**ADDENDUM REPORT
ON**

**TEMPORARY ACCESS ROAD
MISSISSIPPI RIVER WETLANDS
HIGHWAY 417
W.P. 451-90-03/04
ARNPRIOR, ONTARIO**

December 1999

FIGURE 5

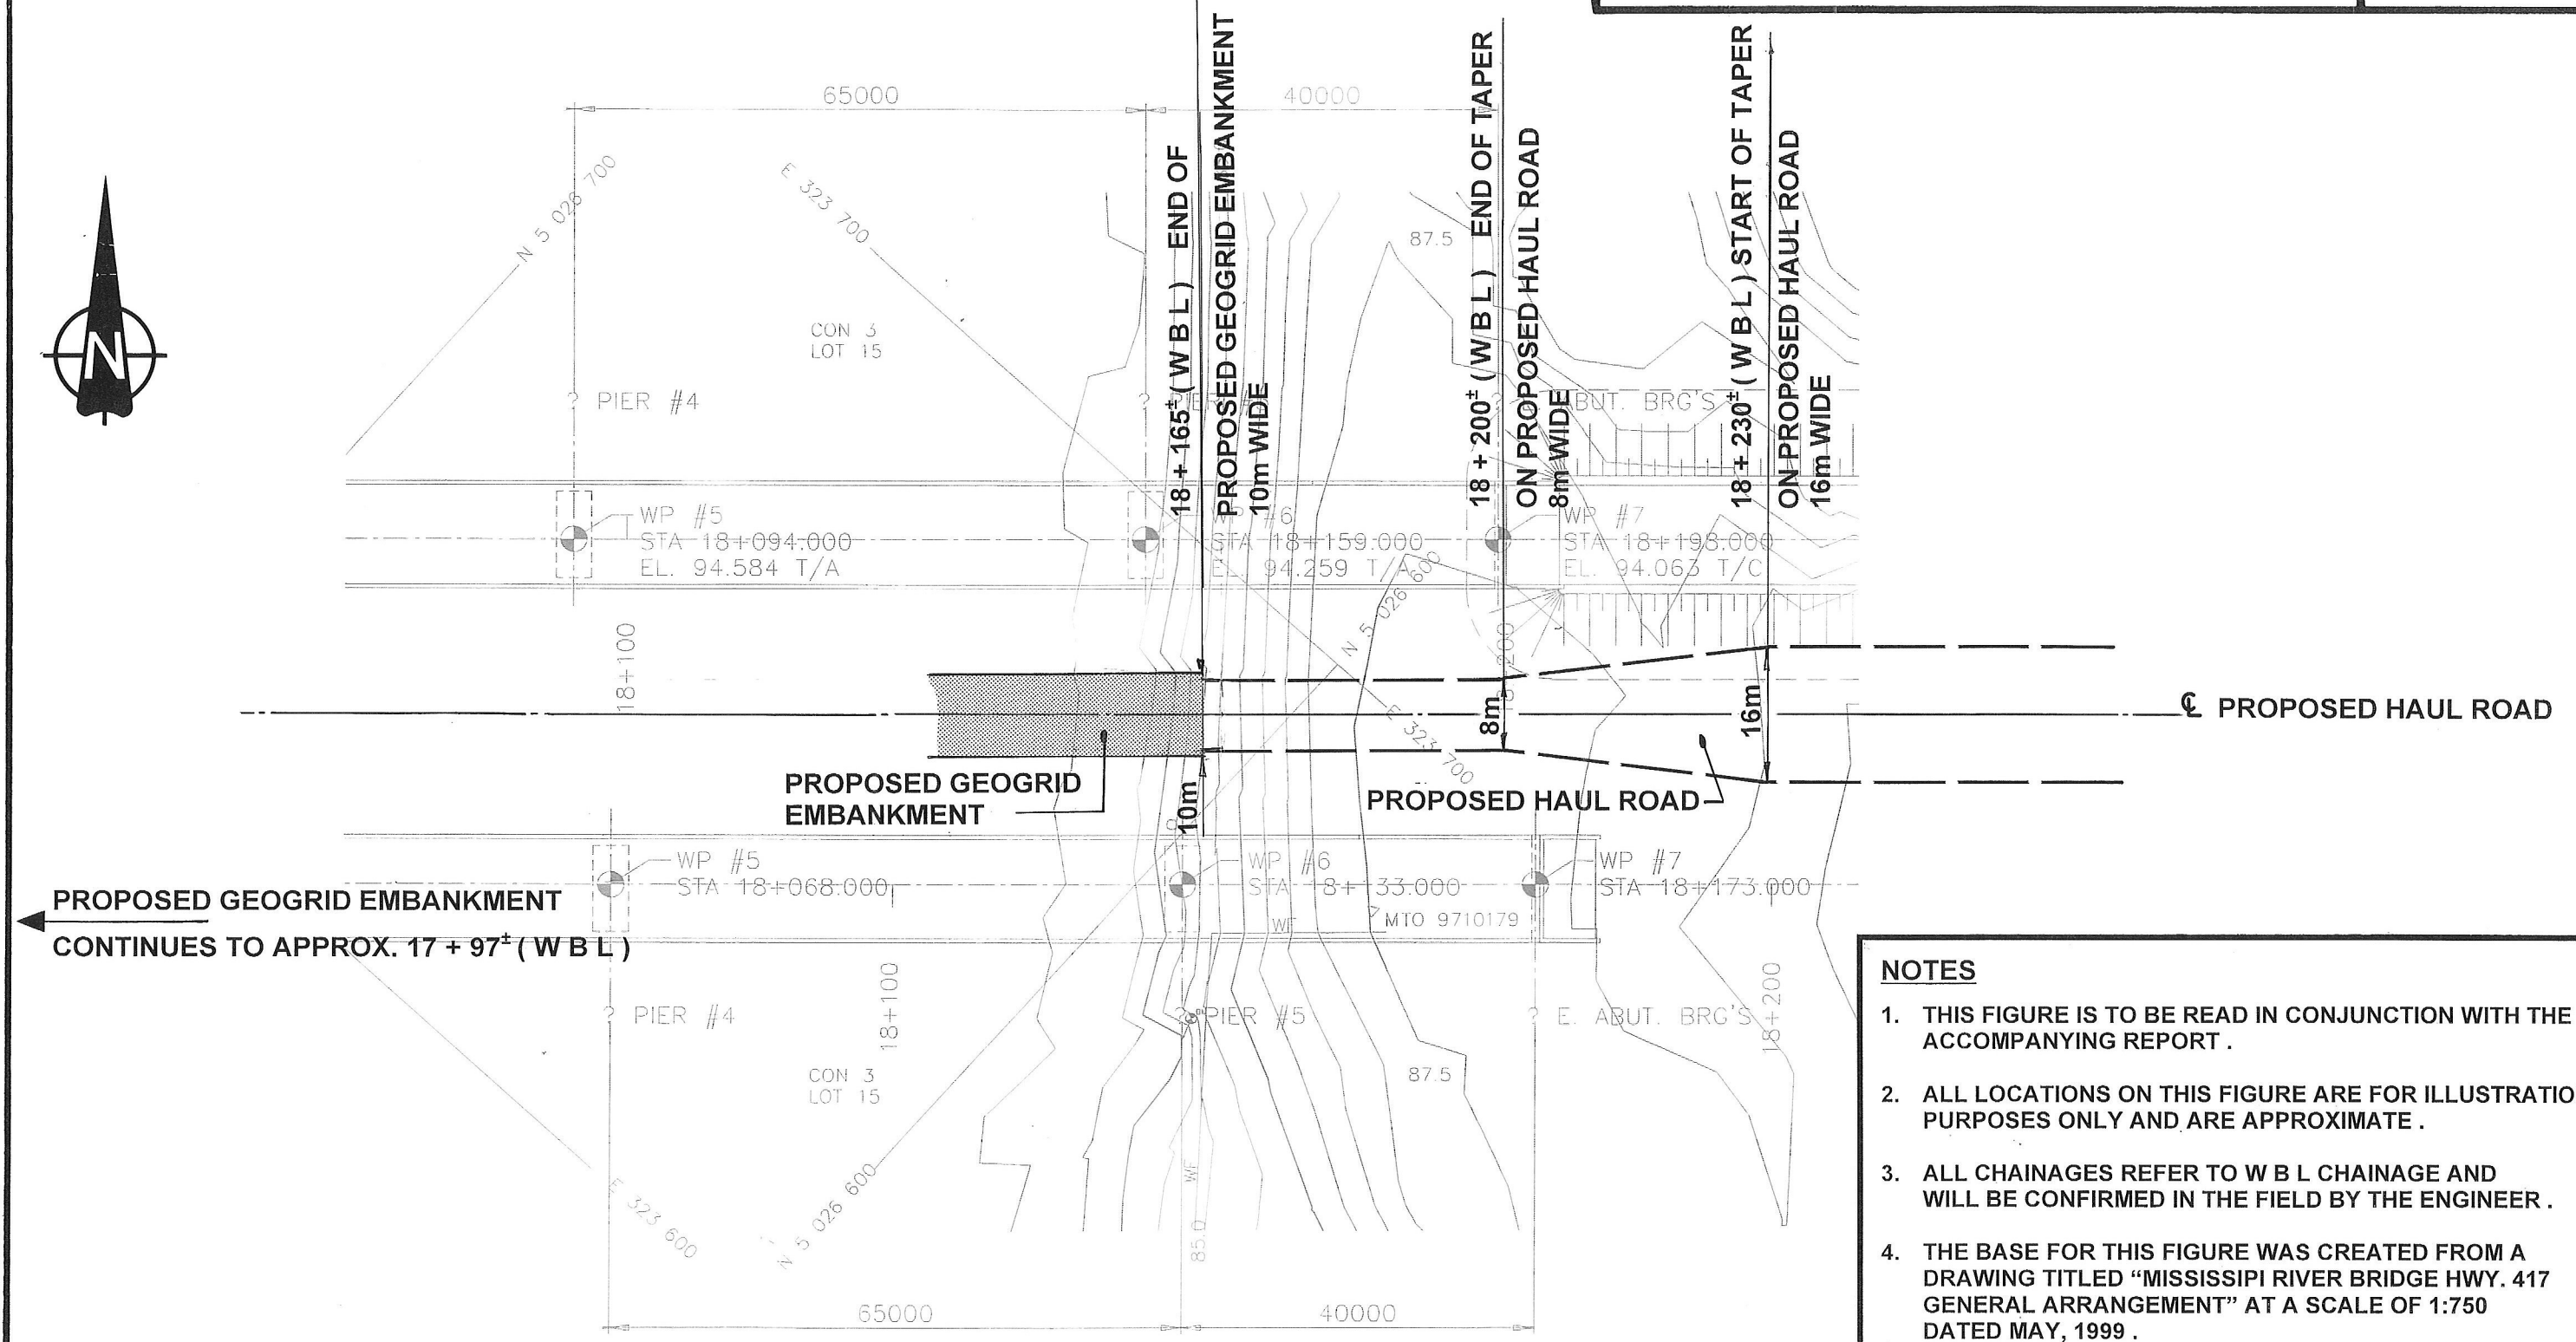
embankment and the haul road fill construction between approximate Station 18+150 and Station 18+160. It would not be possible to determine the precise easterly limits of the geogrid embankment until the time of construction by the contractor. The conditions easterly beyond Station 18+150 (WBL) are somewhat favourable and the proposed 1.5 m geogrid embankment may not settle to the extent elsewhere and possibly maintain at Elevation 84.3 m. In such a case the 8% gradient could be terminated at approximate Station 18+154 (WBL) which will smoothly blend with the geogrid embankments. A plan showing the haul road from Station 18+154 to about station 18+250 WBL is shown on Figure 5.

MTO HIGHWAY 417	
ARNPRIOR,	ONTARIO
GEOGRID LAYOUT	
Sheet Number 5A of 5

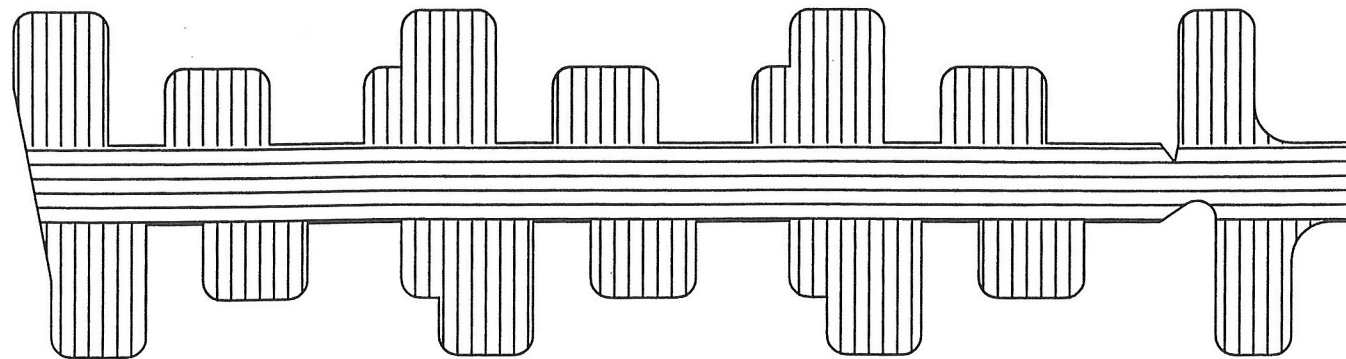
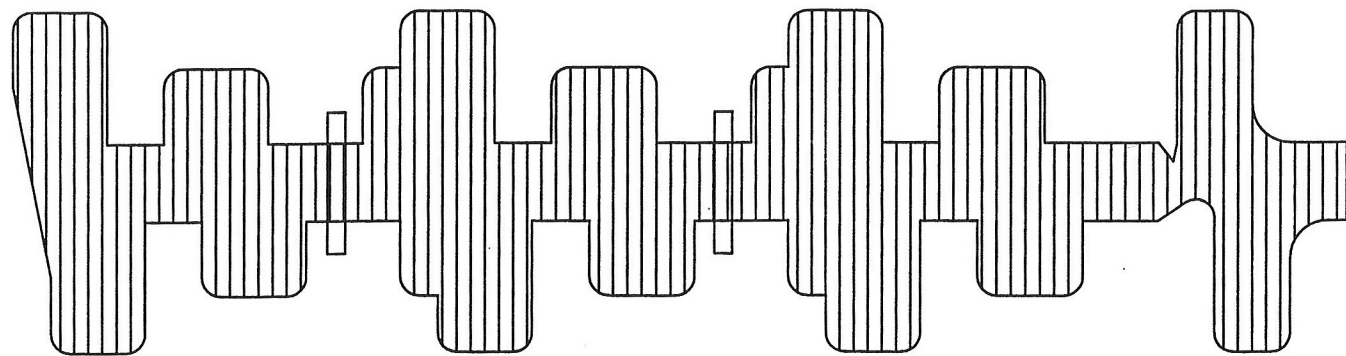
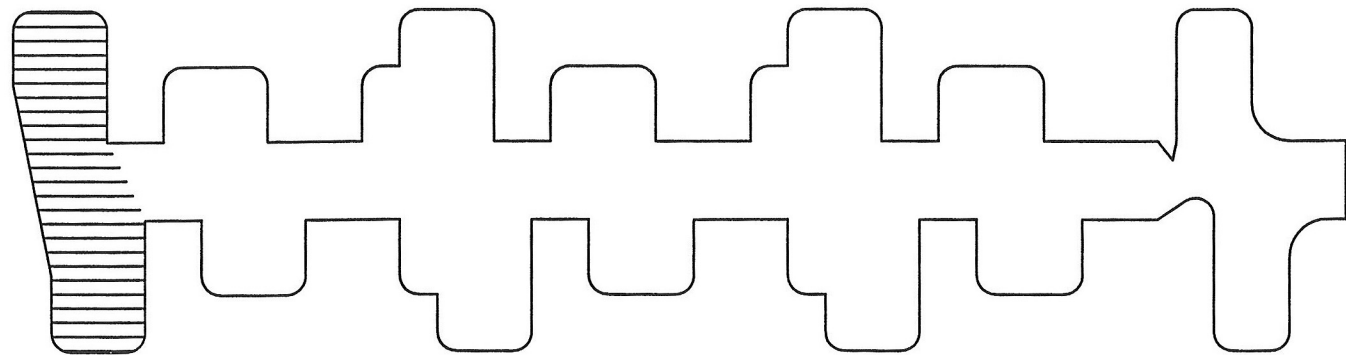
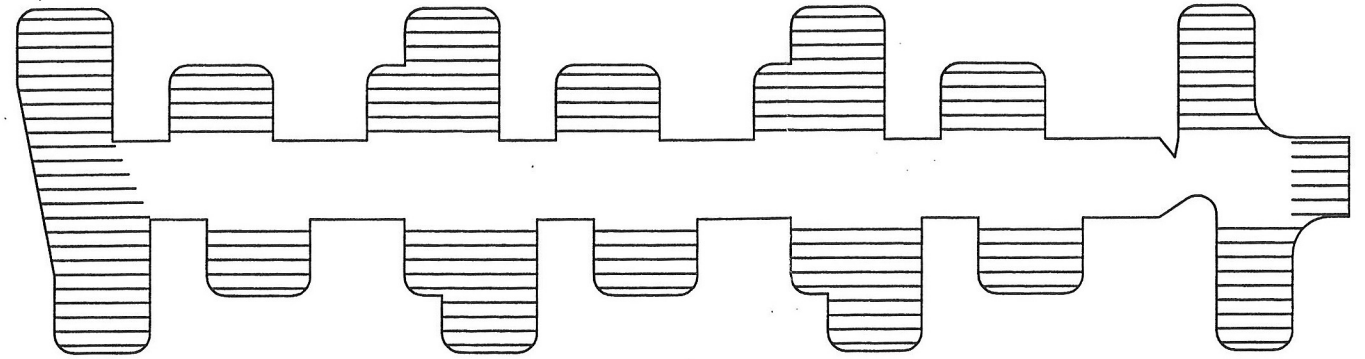
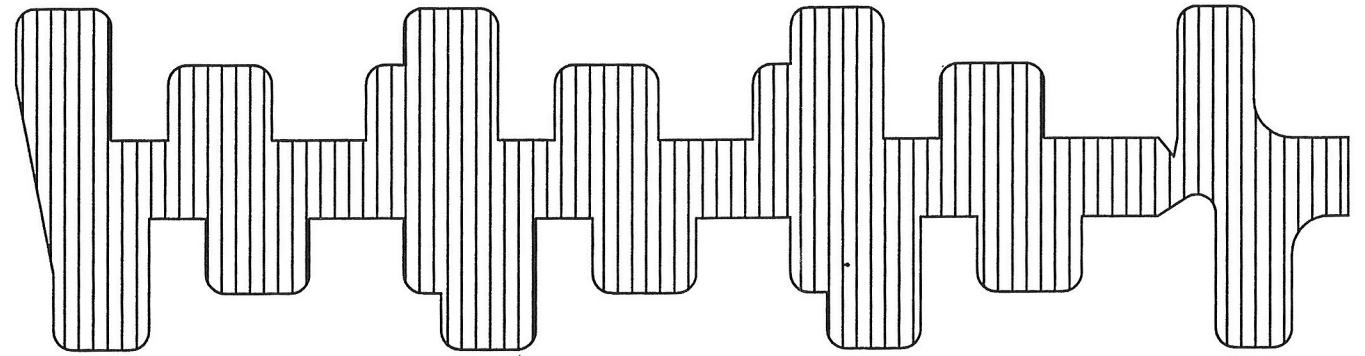
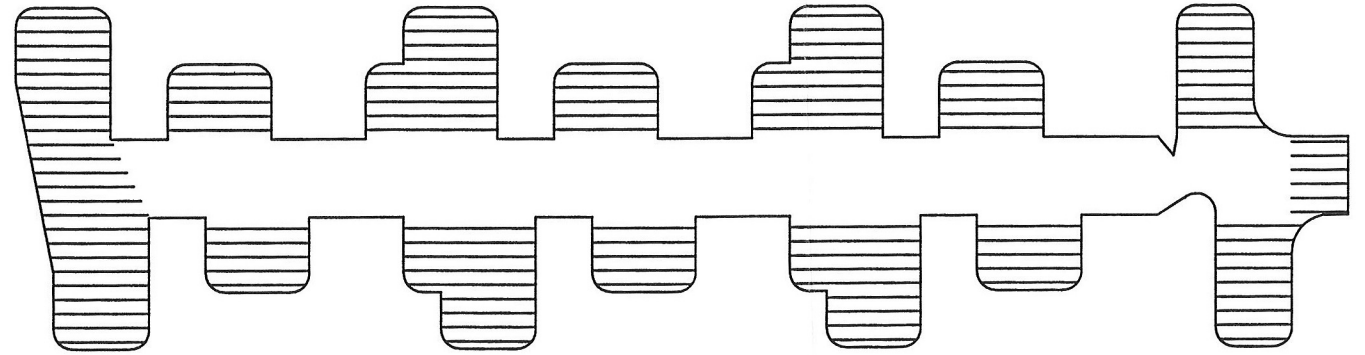
experience. This pipe has the strength and flexibility to accommodate the anticipated deformations. The pipe is available with an inside 0.460 m smooth wall diameter. Care should be exercised to prevent any damage to the pipe by providing adequate cover to the pipe during the construction of the embankment. Installation details are given on the construction notes of Sheet #2 of #5 Tensar drawings. Details are also shown on typical cross-sections (Drawing #3 of 5) and the locations on geogrid layout (Drawing #5 of 5) which are included in the appendix of this report. The 0.5 m diameter pipe could be installed at three different locations to provide passage for the fish. If 0.5 m diameter pipes are not adequate, larger diameter pipes could be considered but not larger than 0.75 m due to the vertical space restrictions between the geogrids. We also investigated a corrugated High-Density Polyethylene smooth wall pipe with outside diameter of 0.735 m with inside diameter of 0.611 m. However with the 0.735 m diameter pipe there may not be adequate cover at certain stages of the embankment construction. In such case additional granular cover would be necessary to prevent damage to the pipe from the equipment traffic. The details are shown on typical cross-sections (Tensar Drawing No. #3A of 5). If crane traffic warrants further precautions to ensure the integrity of the pipe, timber matts can be used in the pipe area. If larger diameter 0.735 m pipes are necessary, these could be placed at only two locations instead of three locations for 0.544 m diameter pipes. The locations are shown on the geogrid layout (Tensar Drawing #5A of 5).
